REMEDIATION SYSTEM EVALUATION

McCORMICK AND BAXTER
SUPERFUND SITE
PORTLAND, OREGON

Report of the Remediation System Evaluation,
Site Visit Conducted at the
McCormick and Baxter Superfund Site
August 23-24, 2001

Final Report
February 8, 2002

FIGURE 1-2. LAYOUT OF THE McCORMICK AND BAXTER PROPERTY INDICATING FORMER FACILITY STRUCTURES, PRIMARY CONTAMINANT SOURCE AREAS, PERTINENT SITE FEATURES, AND APPROXIMATE LOCATION OF THE PROPOSED VERTICAL BARRIER WALL.

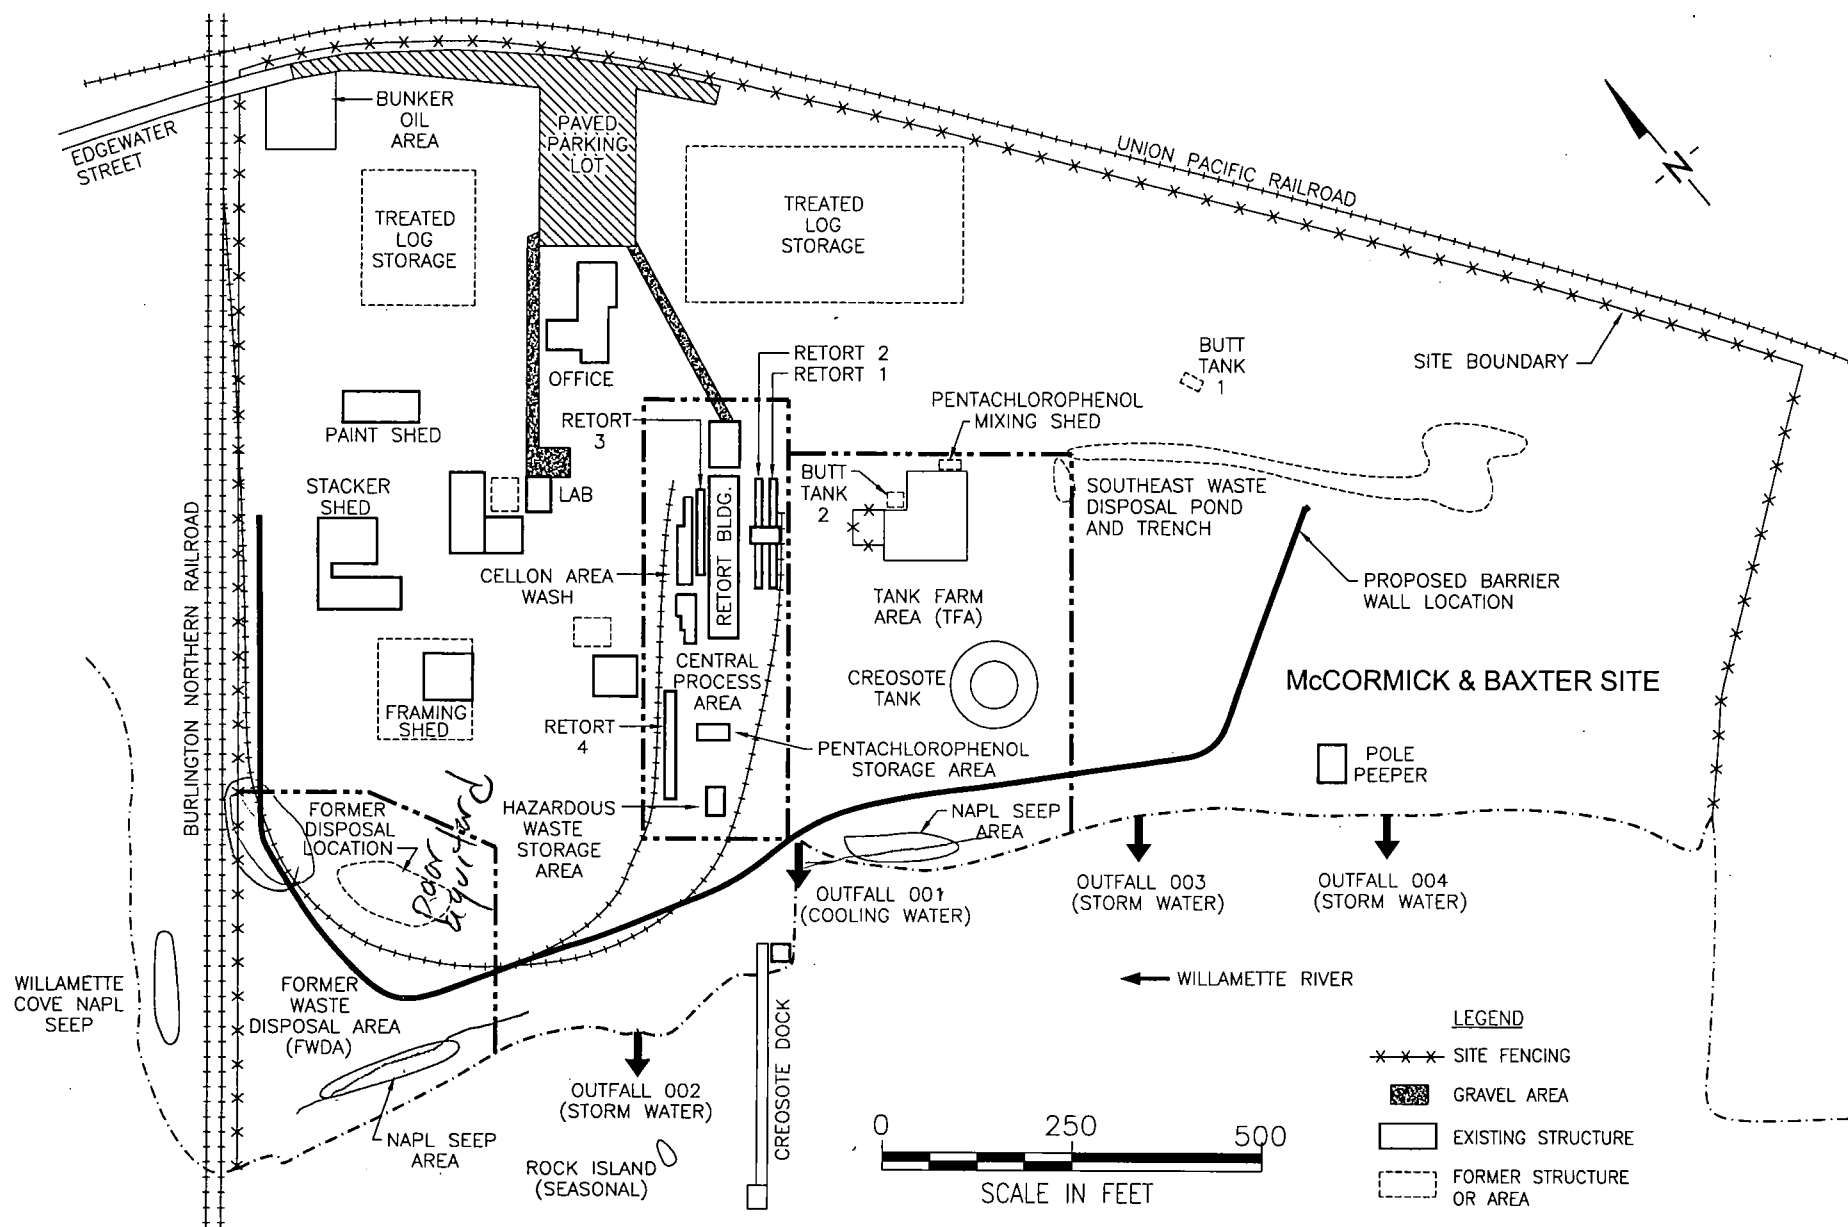
Vertical Barrier Wall: A vertical barrier is being considered by the site managers to prevent migration of LNAPL and to some extent DNAPL, from the source areas. Downgradient (partially encompassing) or totally enclosing configurations have been discussed for the application. The totally enclosing configuration could increase the cost by approximately \$500,000 but offers no tangible benefit over the downgradient location. A totally encompassing wall may even require more maintenance than a partially enclosing wall because water would potentially have to be extracted and treated from the totally encompassing wall to offset natural recharge. A groundwater model for the site, however, suggests such extraction would not be necessary due to a lack of a competent aquitard in the FWDA. Wells or drains upgradient of the wall can be used to help collect product although barrier walls do not necessarily increase the ability for NAPL extraction.

Disadvantages: A significant but unquantified percentage of mobile NAPL has already migrated past the wall location and could continue to discharge to the river for several years after wall installation. In some areas, including the FWDA and 100 feet between MW26s and MW-30s (according to Figure 4-25 in the 1992 Remedial Investigation Report), a barrier wall cannot be keyed into an underlying low permeability layer since none exists, and DNAPL migration in

According to the site managers, a barrier wall will be installed and will likely have a configuration similar to that shown in Figure 1-2. It will be keyed into the low permeability layer in most areas where one exists but will be "hanging" in areas like the FWDA where the low permeability layer does not exist. The site managers expect the wall to contain the unquantified amount of NAPL remaining onsite. Efforts, however, may be required to prevent migration of NAPL through the "hanging" portions of the wall. Due to the lower installation costs, site managers will likely have the wall constructed of a bentonite slurry rather than sheet piling.

Because the planned barrier wall will be approximately 50 feet from the edge of the river and 500 feet from the outer limit of the NAPL contaminated sediments, a significant amount of mobile NAPL may exist beyond the influence of the wall and may continue to impact the river through seeps. To contain some of this NAPL, interceptor trenches may be installed along the beach in both the Willamette

Consistent with the site management's decision, the RSE team recommends a phased approach to implementing these strategies as construction or implementation of one element may change the design parameters of the other units or yield valuable site information pertinent to the implementation of the other elements. For example, construction of the barrier wall may indicate the vertical extent and location of NAPL seeps. Such information would be useful in the final design and implementation of possible cutoff trenches or the sediment cap. Such information would also be useful in designing a monitoring program for evaluating the effectiveness of the implemented strategies. Given the timeframe of implementation presented by the site managers, the barrier wall will hopefully be installed in Spring of 2002, and installation of the cap may wait until the winter or the following summer. Thus, ample time will be available to incorporate information gained through wall construction or through monitoring of site conditions after the wall is constructed.
